UNITED STATES PATENT AND TRADEMARK OFFICE

APPLICATION NO.	FILING DATE	FIRST NAMED INVENTOR	ATTORNEY DOCKET NO.	CONFIRMATION NO.
10/019,475	08/09/2002	Willi Neff	127FR/50787	5559

Office Action Summary	Application No.	Applicant(s)	
	10/019,475	NEFF ET AL.	
	Examiner	Art Unit	
	Courtney Thomas	2882

DETAILED ACTION

Figure 5 – U.S. Patent 6,031,241 to Silfvast et al.

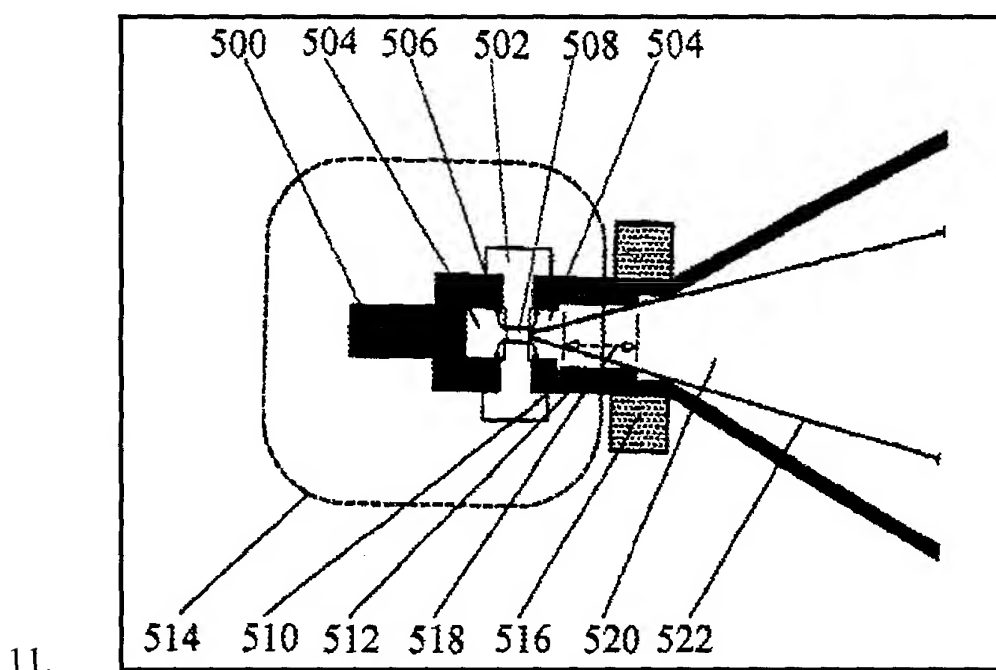
12. **As per claim 1**, Silfvast et al. disclose a device comprising two main electrodes (500, 510), between which there is a gas filled space (not labeled above), wherein each of the two main electrodes (500, 510) exhibits an opening, defining an axis of symmetry, and wherein the electrodes (500, 510) are formed in such a manner that a gas discharge forms exclusively in the volume, determined by an alignment of the openings; and where a plasma channel (508) generated on the axis of symmetry is the source for at least one of the extreme ultraviolet (EUV - 522) and X-rays and means for increasing conversion efficiency (514, 516, 512, 520 – see Fig. 5, above).

13. **As per claims 2-7 and 11**, Silfvast et al. disclose a device wherein at least one of the openings on the side facing away from the space is larger than on the side facing the space; wherein the openings exhibit the shape of a truncated cone and wherein an auxiliary electrode (512) is provided behind the opening of one of the main electrodes and a pulse forming network is provided as a power supply (see Fig. 5, above – column 1, lines 29-67; column 2, lines 1-52).

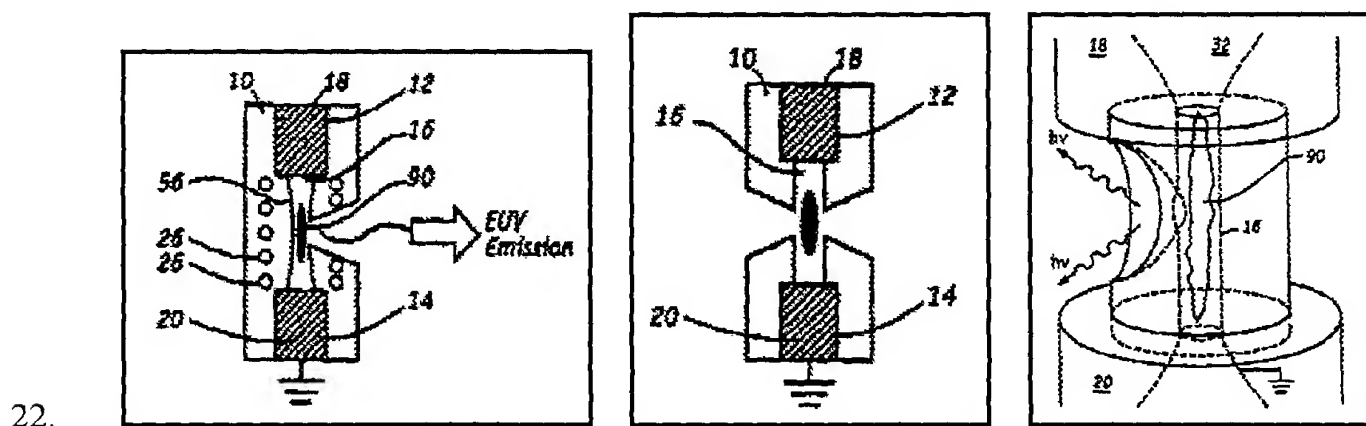
23. U.S. Patent 6,654,446 to Bender, III discloses several structures for EUV emission (see above Figs).
